SB-10055203-4147

Compressor Discharge Line
LEU, MRU

FSB 561-024, Compressor Discharge Line

(February 2014)

W5085642

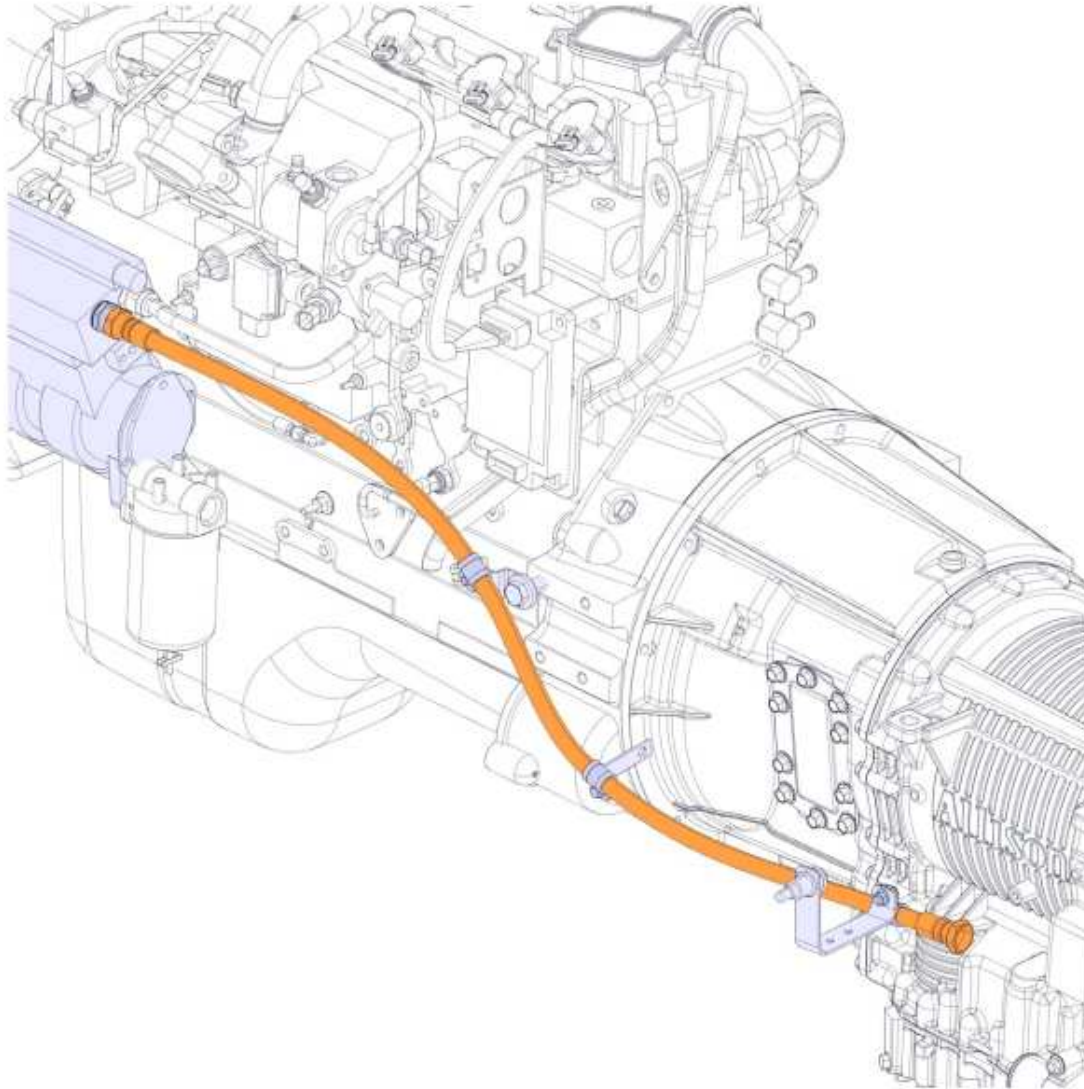
On LEU633 and MRU633 models built between March 2012 and August 2013 the brass collar that is crimped onto the stainless steel compressor discharge line may split, resulting in the inability of the unit to build air pressure. The original part numbers of the Stainless Steel line assembly that are affected are: 25195537, 25192424, and 21628882. Should a failure occur the discharge line should be replaced with the new compressor discharge lines that have a steel collar.

- 1 Raise the cab.
- 2 Remove clamps securing main air line.
- 3 Disconnect braided line.
- 4 Install the replacement braided line. Tighten securely.
- 5 Install clamps securing main air line.
- 6 Start engine. Build air to maximum pressure and check for leaks.
- 7 Lower cab.
